**LaSalle Environmental Audit
Response to Request for Additional Information**

Index #: 011 **RAI #: AQ-01** **Category:** Aquatic Ecology

CW Inlet Temperature - 2005 Fish Kill

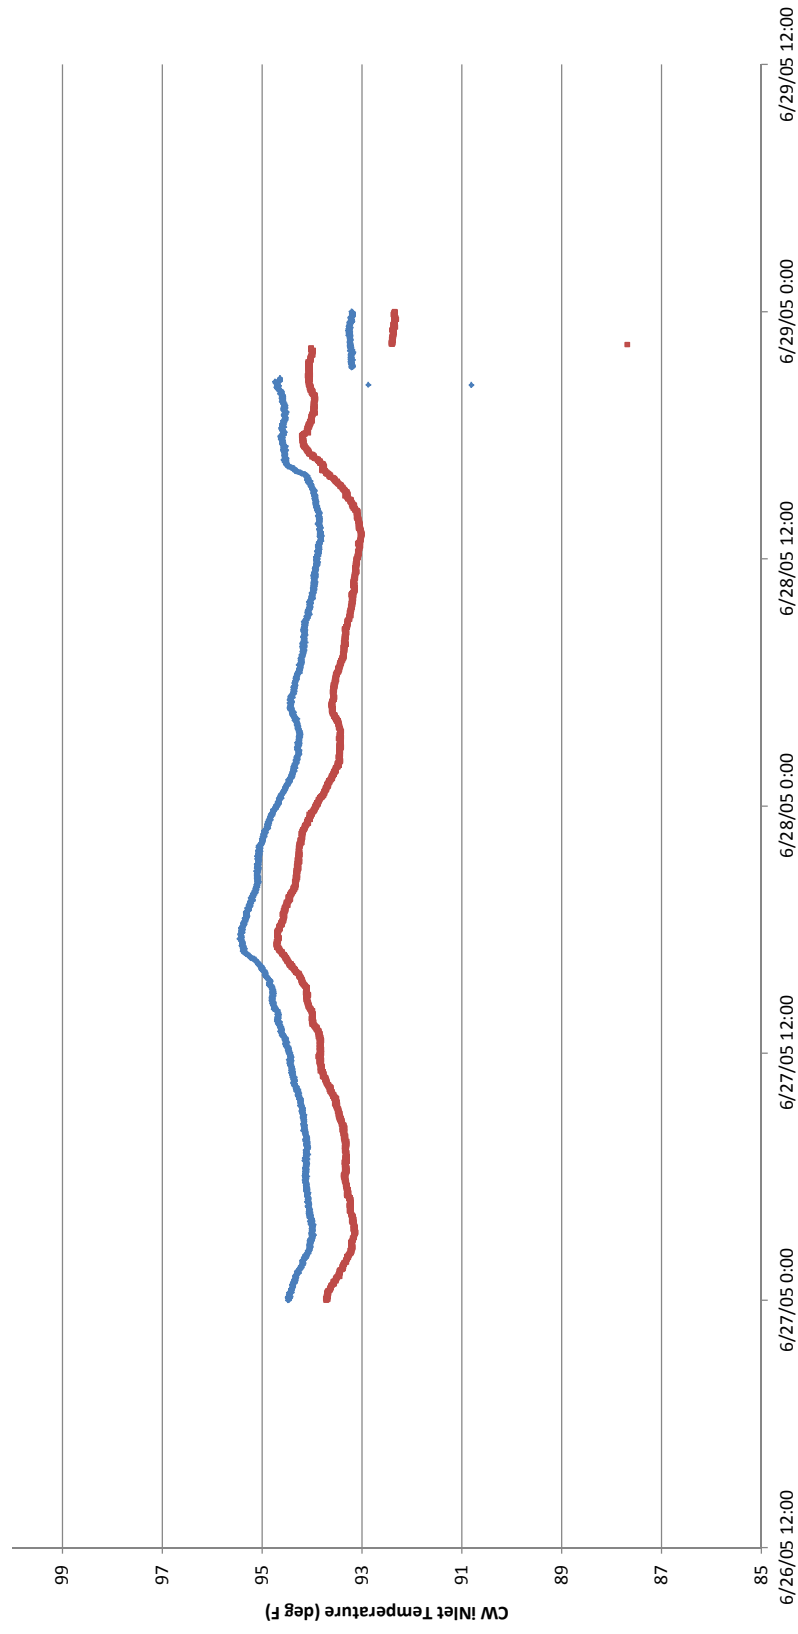
- a. Provide the date of the unreported fish kill in 2002. In addition, summarize the species of fish that were affected by the fish kill.
- b. Provide the temperature in the cooling pond during the 2005 fish kill event (June 27 28, 2005). In addition, summarize the species of fish that were affected by the fish kill.

- a. The 2002 unreported fish kill mentioned in the ER was recorded in Exelon's Action Tracking system on July 5, 2002. The record indicates that approximately 100 fish were found dead near the shad nets in the vicinity of the Lake Screen House. The species of the dead fish were not described.
- b. Temperature monitoring in the cooling pond occurs in the intake to the Lake Screen House. Data from this location for June 27 to 28, 2005, which is the time period over which the 2005 fish kill event occurred, is provided as Attachment 1 to this RAI response.

As was reported to the NRC in a letter dated July 28, 2005 (NRC ADAMS Accession # ML052200481), on June 28, 2005 at 1245 CST, a fish kill above normal mortality was identified on the station cooling pond. The initial estimate was reported as approximately 300 fish, mostly Striped Bass hybrids. The Illinois Department of Natural Resources (IDNR) was notified and an ENS notification was made pursuant to

CW Inlet Temperature 2001-2014

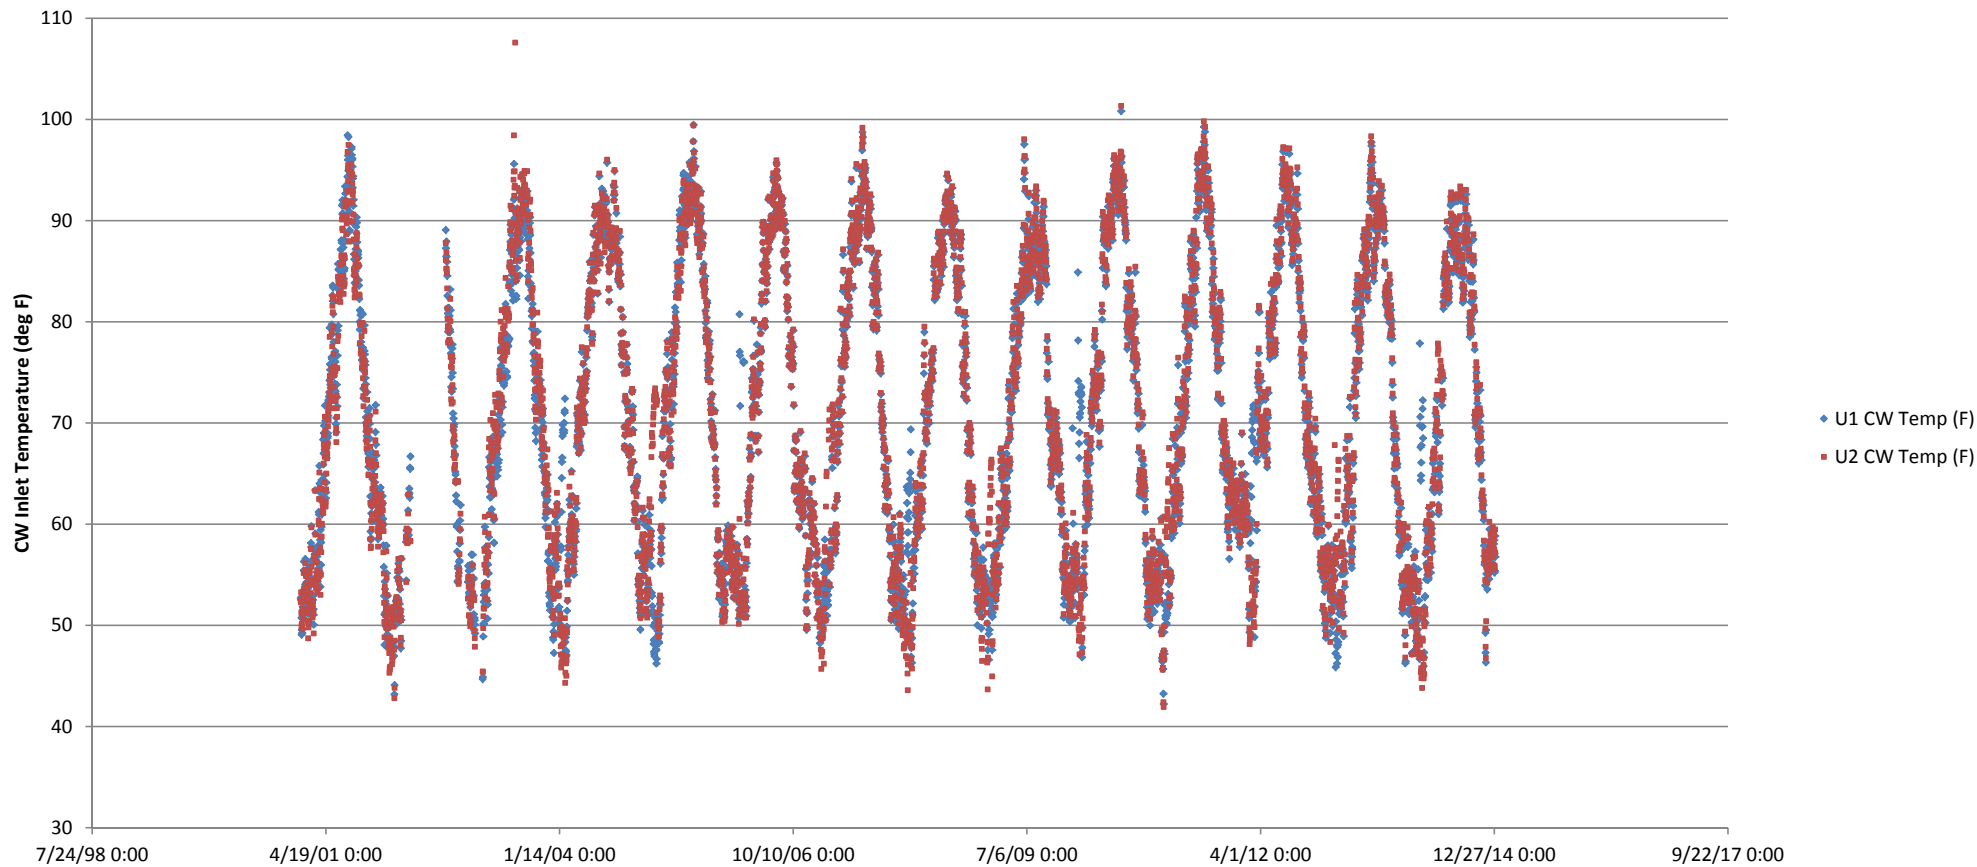
- c. Provide a summary of the temperature in the cooling pond (intake at the lake screen house) since 2001. In addition, provide the daily maximum cooling pond blowdown temperatures from the monthly NPDES Discharge Monitoring Reports during July 2001, June 2005, June 2009, and August 2010.

- c. Attachment 2 to this RAI response contains a summary graph of the LSCS circulating water intake temperatures as measured at the lake screen house. Attachment 3 to this response contains daily maximum cooling pond blowdown temperatures as reported in the monthly NPDES Discharge Monitoring Reports for July 2001, June 2005, June 2009, and August 2010.
